Development Review Committee

STAFF REPORT

Re: <u>Bainbridge Phase 1 – Final Subdivision Plat Request</u>

Application No.: 2023-4524-SUB

EXHIBIT F FINAL SUBDIVISION PLAT

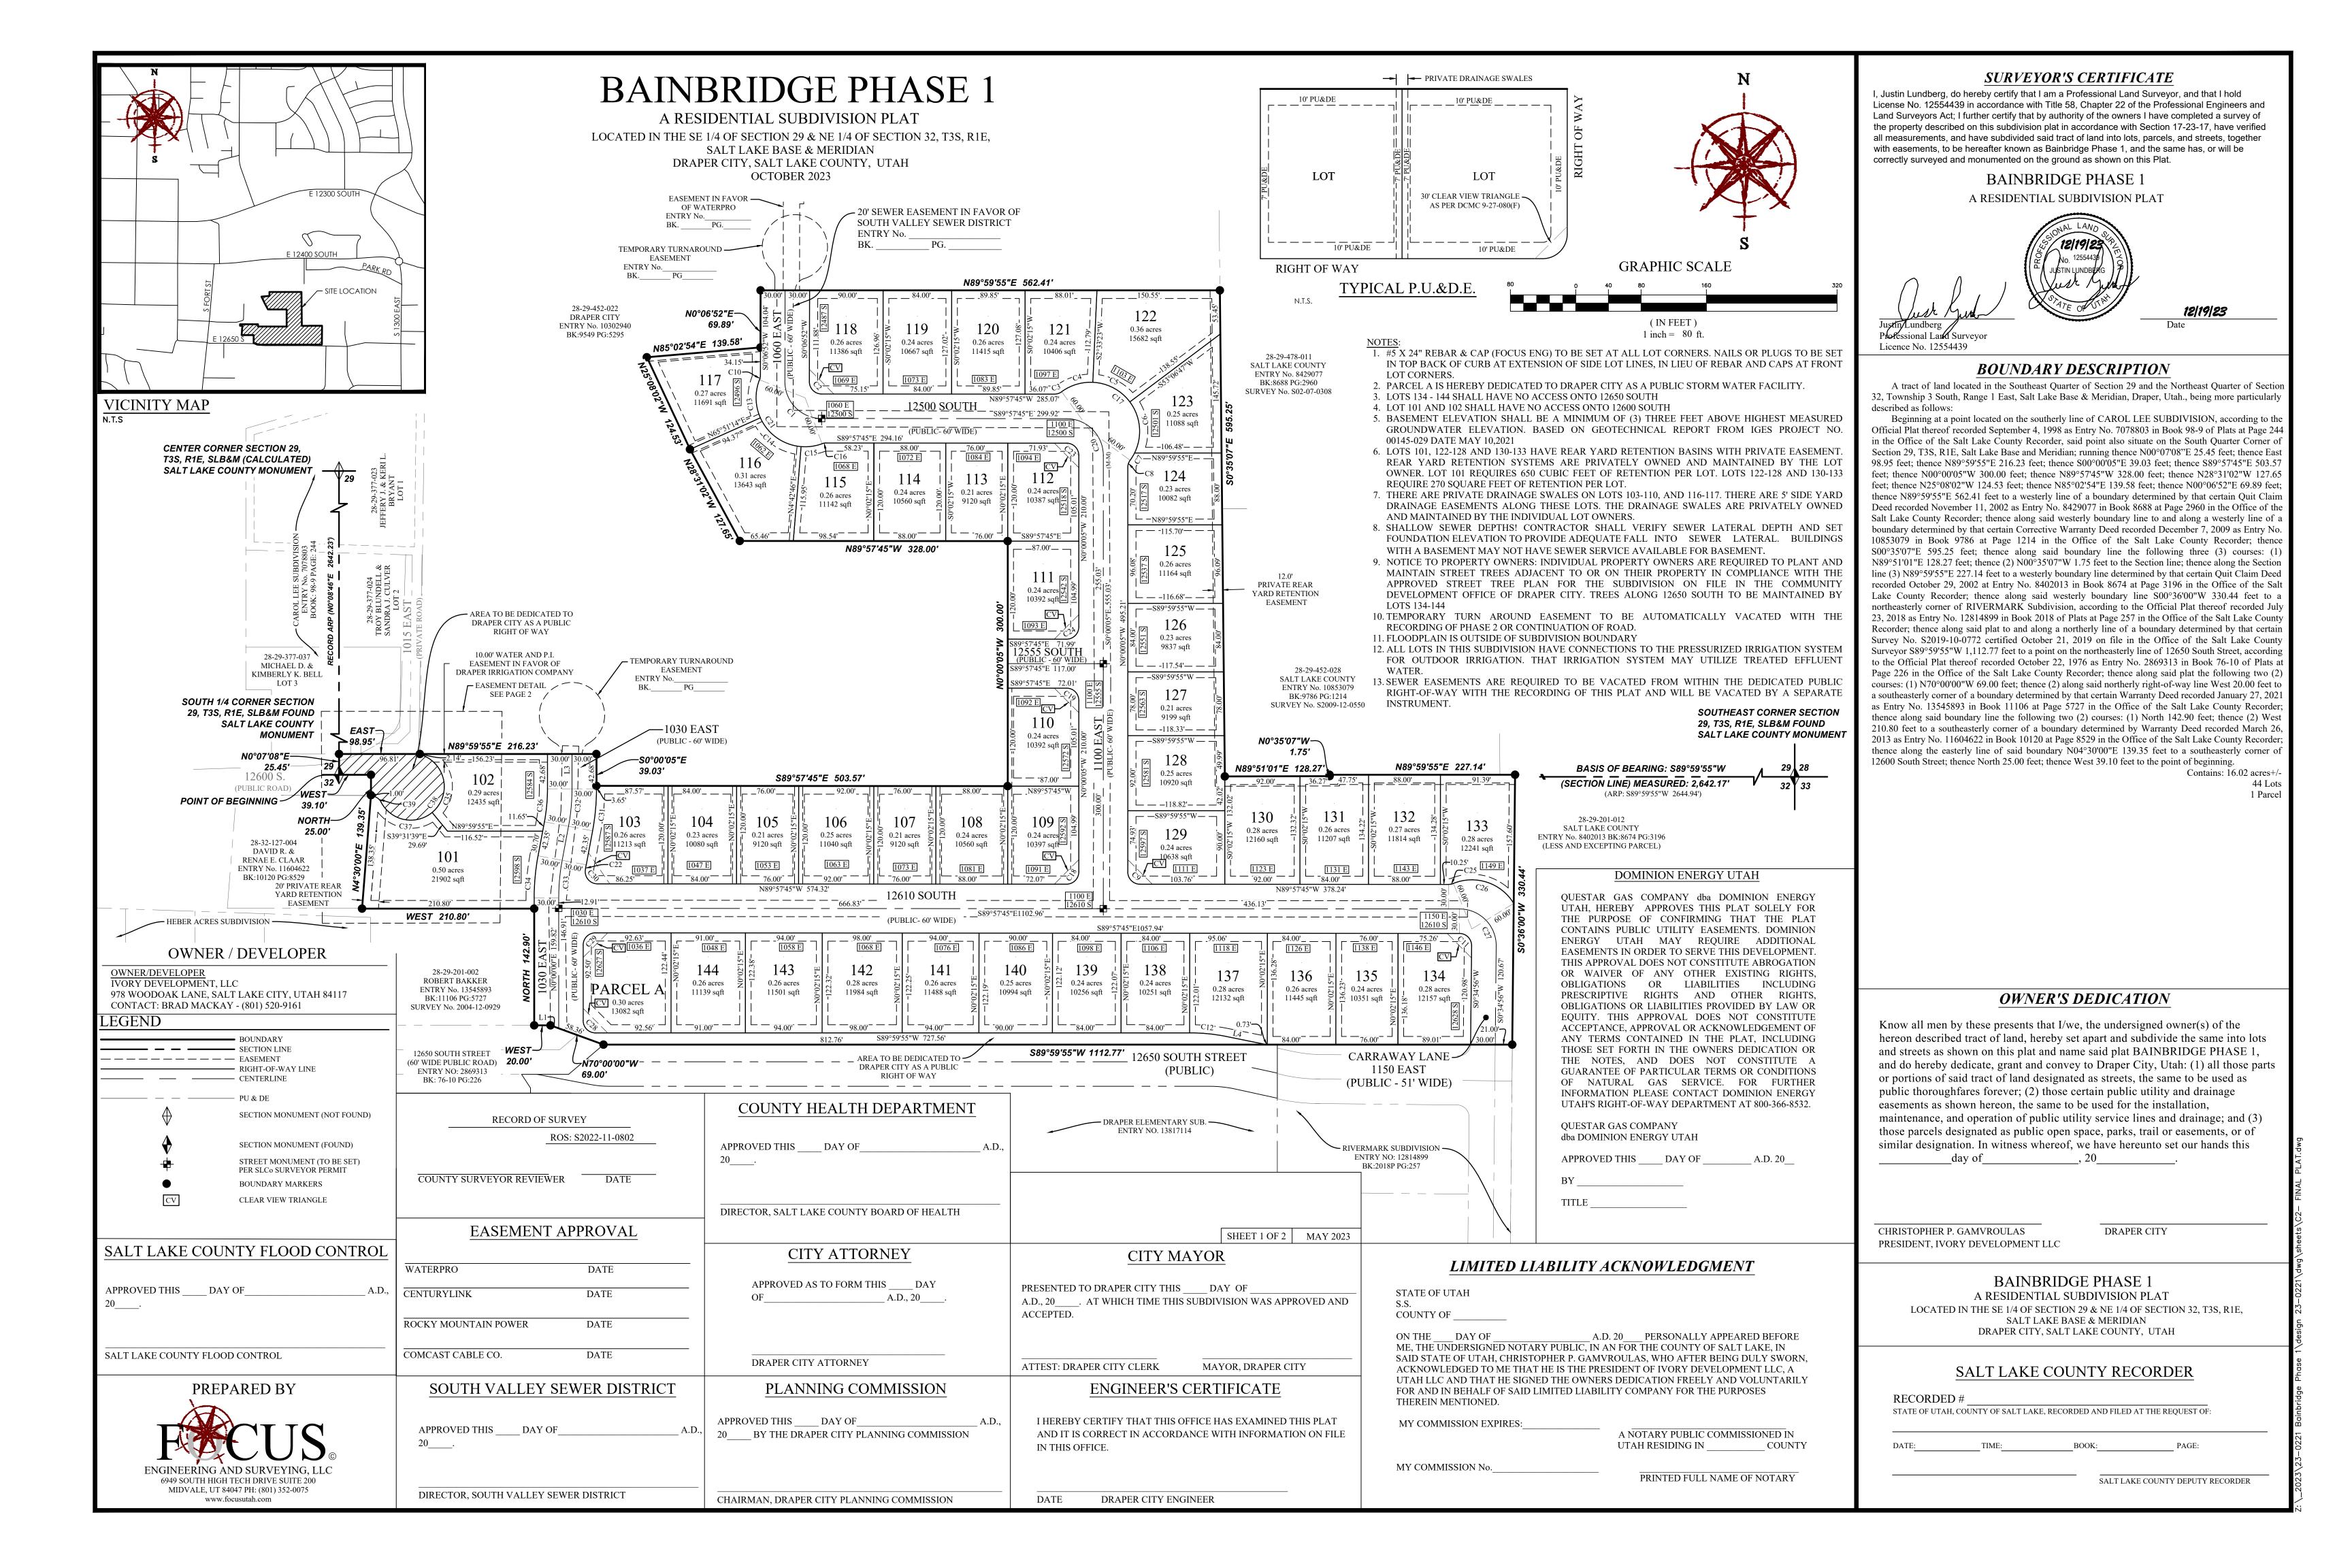
- 9. Temporary turn-around easement required at lots 117-118. Proposed temporary turn-around easement is on the city's property. City council is required to authorize the easement city staff does not have the authority to approve it.

- 10. WaterPro easement across the city's parcel (north of Phase 1) is required to be approved by city council.
